CITY OF WEST LAKE HILLS, TEXAS
NOTICE OF BOARD OF ADJUSTMENT (BOA) REGULAR MEETING
Wednesday, December 8, 2021 at 7:00 PM

- a. Approval of the November 10, 2021 Regular Meeting Minutes
4. Land Use **1505 Wildcat Hollow**: Discuss and Consider Action on an Appeal of a Staff Decision for Denial of a Building Permit. (West Lake Hills Code Sec. 38.02.006). Agent Kim Power of Dick Clark and Associates for Property Owner Sergio Alvarez.

ALVAREZ ADDITION
1505 WILDCAT HOLLOW
WEST LAKE HILLS, TX 78746

LEFT ELEVATION - CONNECTION

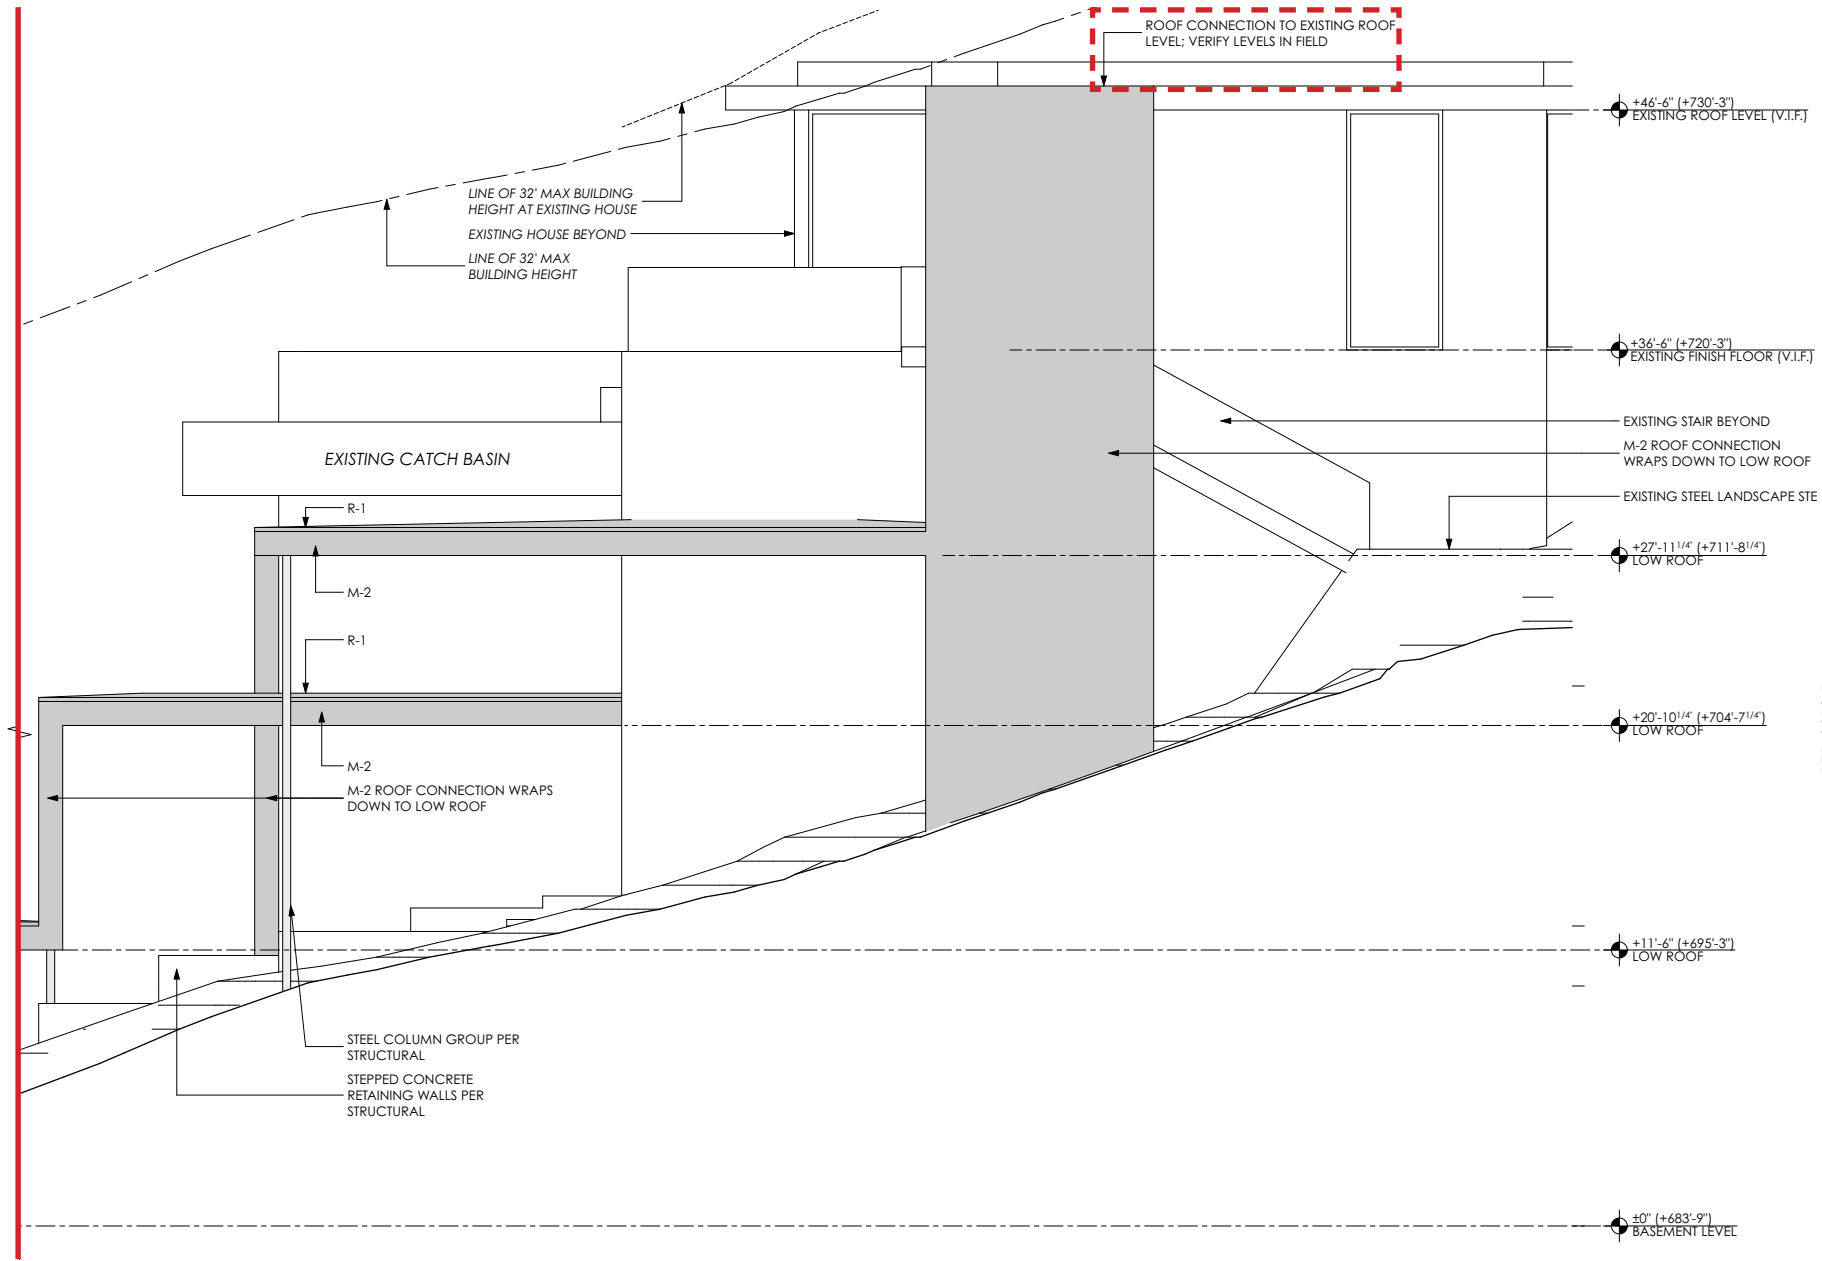
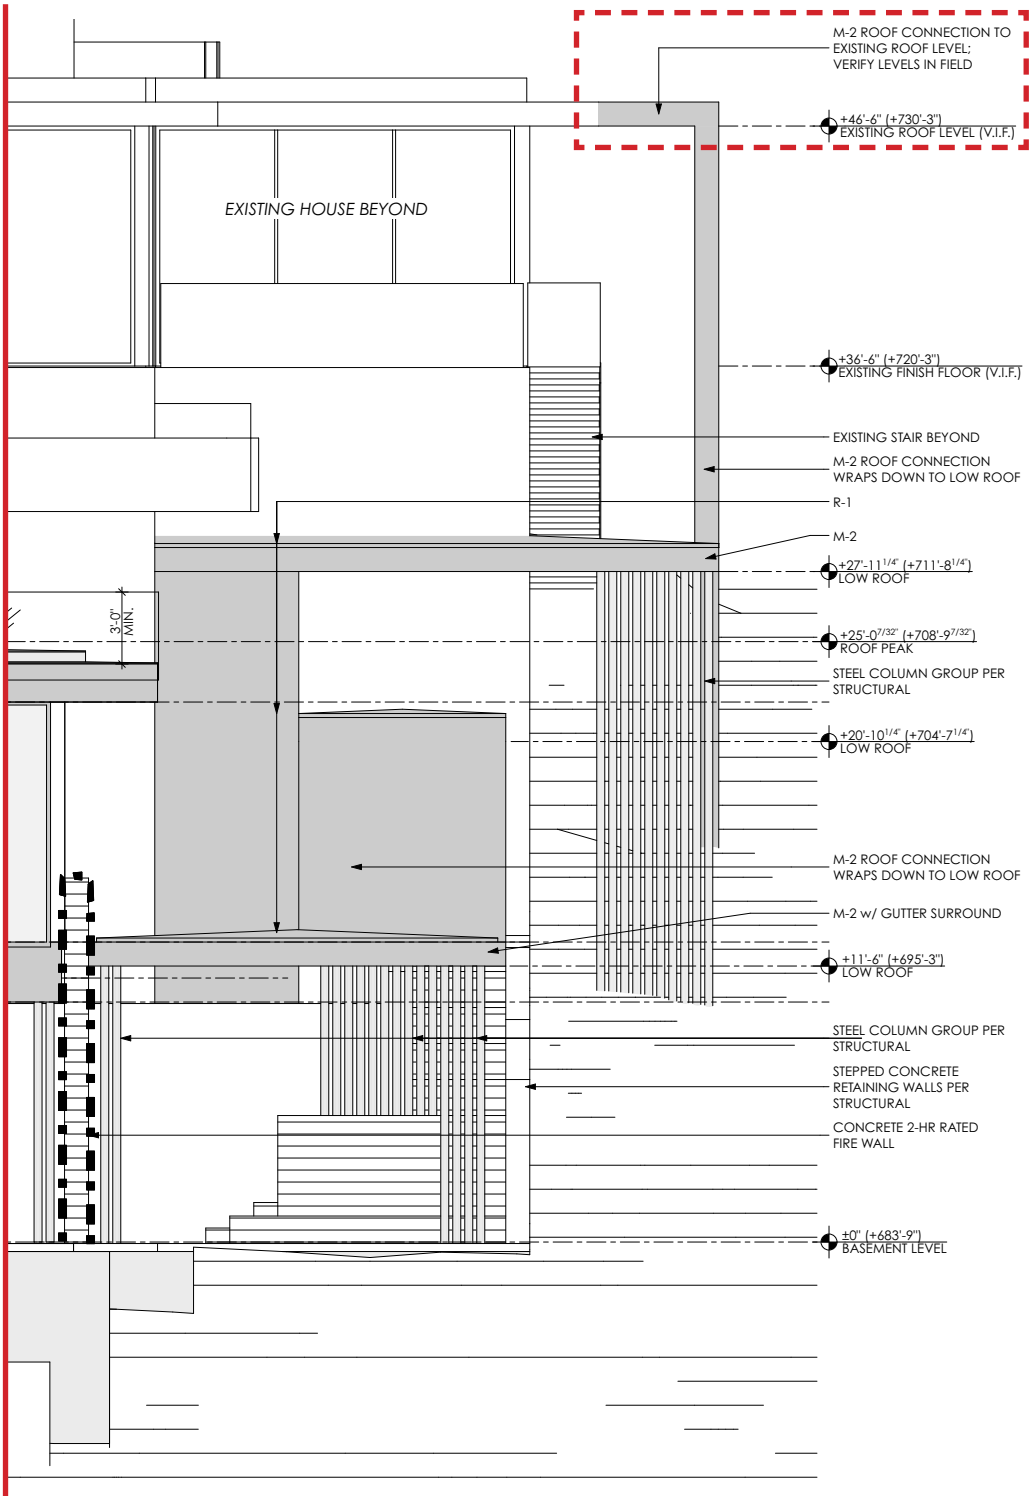
5. Addition does not meet the requirements for accessory structure, a variance is required per Section 38.03.032 and 1.01.003. Please provide proof of code compliance.

01. Proposed addition is not an accessory structure under Sec. 38.03.032 nor 1.01.003 as **the proposed addition is an extension of the existing structure with a continuous roofed connection.** This results in a single "building" per Sec. 1.01.003 definition of "building" as follows: "Any structure, either temporary or permanent, having a roof or other covering, and designed or used for the shelter or enclosure of any person, animal or property of any kind, including tents, awnings or vehicles situated on private property and used for purposes of a building."

02. Per Sec. 1.01.003 definition of "accessory structure", the use of the additional spaces conforms to the definition of "integral to, or customarily incidental and subordinate to the...principal building/structure", as it is additional bedrooms, living spaces, and garage space for the existing home. Nor is the added structure a "guesthouse" by its definition as it will be occupied continuously by a single "family".
